Sub-Regional RTEP Committee PJM South

February 4, 2016

Dominion Transmission Zone

Project Scope Change to Existing Project: B1794

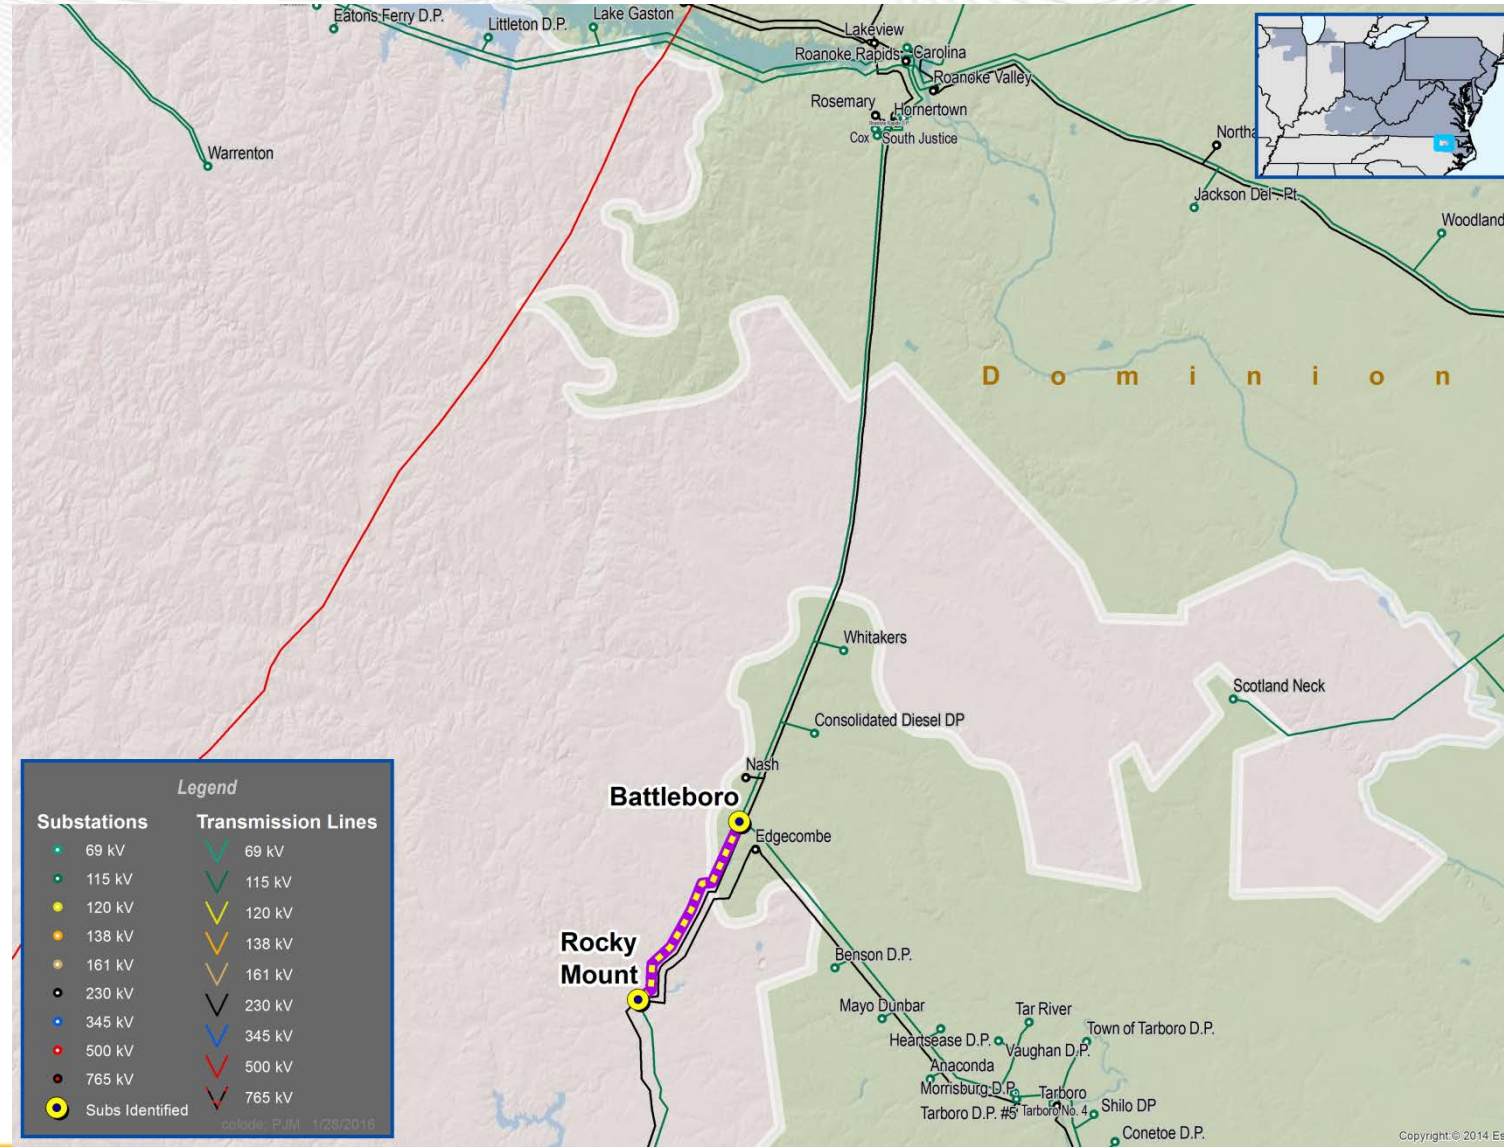
Problem: N-1 Thermal Violation

- Overload of Rocky Mt - Battleboro 115kV for the loss of Battleboro – Carolina 115kV

Reason for Revision

- Original land acquisition was no longer available therefore, a new site was pursued just west of Edgecombe NUG near Hathaway Road (B1794)

New Scope:

- Build a new switching station west of Edgecombe NUG to be called Hathaway Switching Station (previously called Morning Star) with a 230-115kV Tx, 5-230kV breakers in a breaker and half scheme, 4-115kV breakers in a ring. Re-configure Battleboro – Benson 115kV, Nash – Hornertown 230kV, and Edgecombe Nug – Rocky Mt. 230V to terminate into Hathaway Substation (B1794)

Project Cost Change to Existing Project: B2186

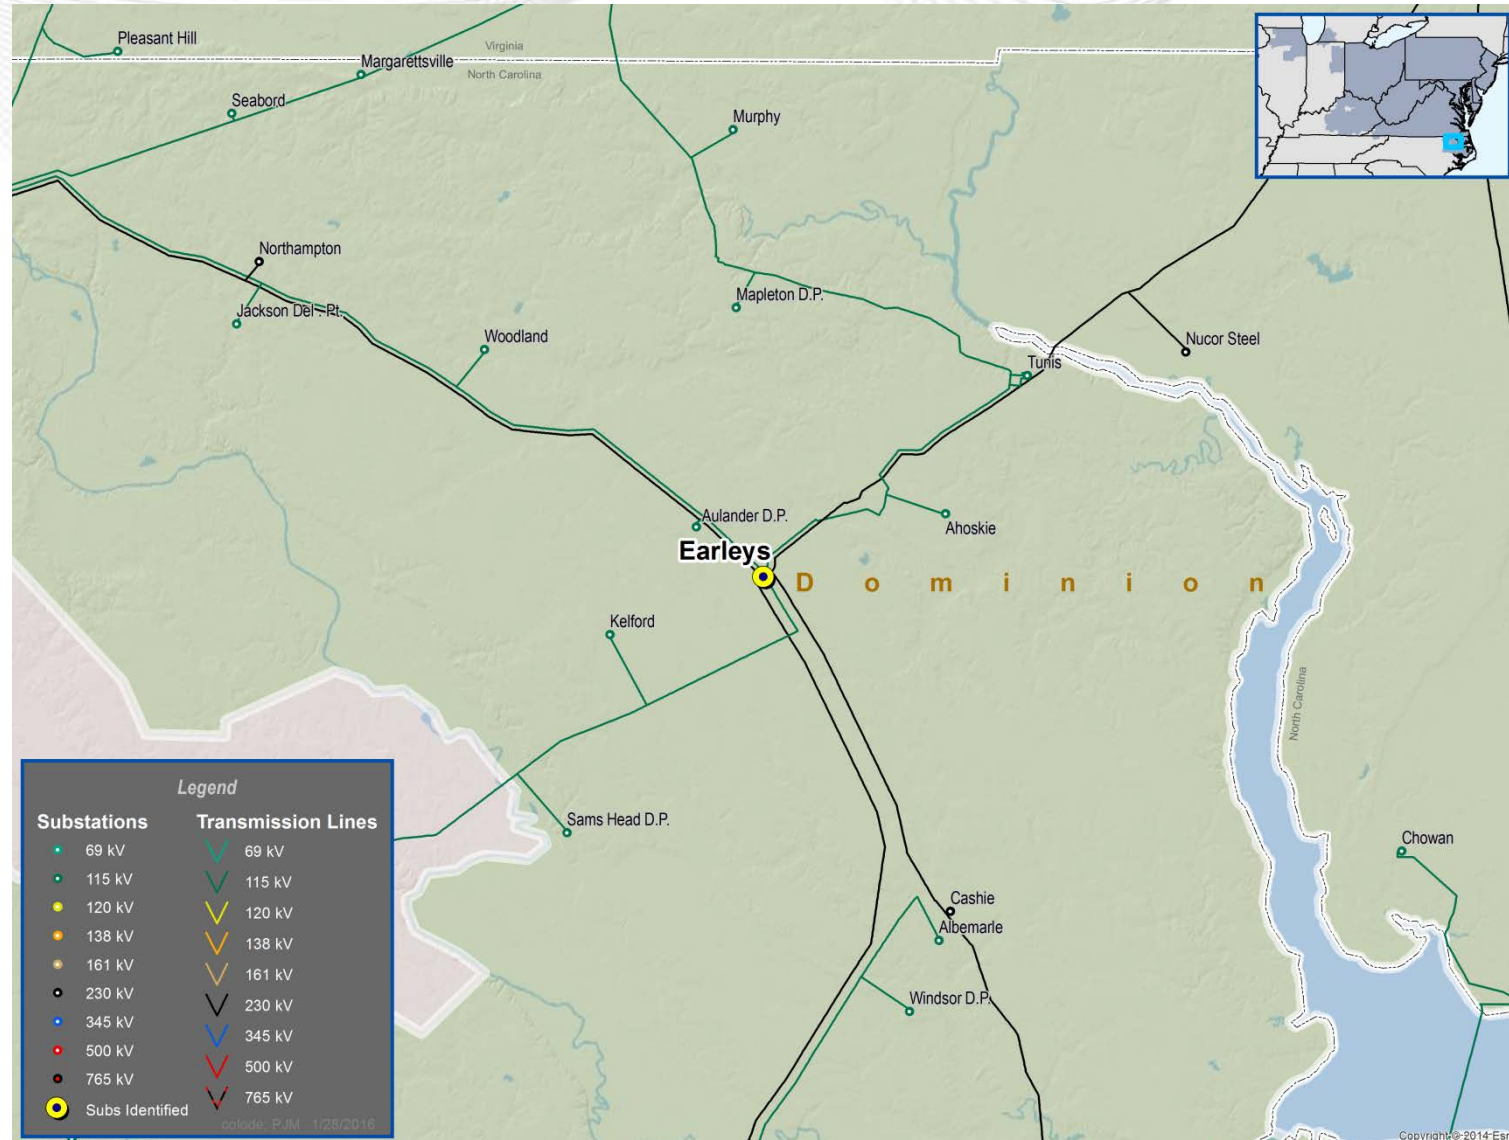
Problem: N-1-1 Thermal Violation

- The loss of Carolina – Earleys 115 kV and the Earleys 230-115kV transformer overloads Boykins – Tunis 115kV

Reason for Cost Change:

- Cost changes reflect increase in construction costs due to equipment being relocated to allow for installation of the required 2nd transformer.

Project Scope:

- Install a 2nd 230-115kV transformer at Earleys connected to the existing 115kV and 230kV ring busses. Add a 115kV breaker and 230kV breaker to the ring busses. (B2186)

Revised Estimated Cost: \$ 11.5 M
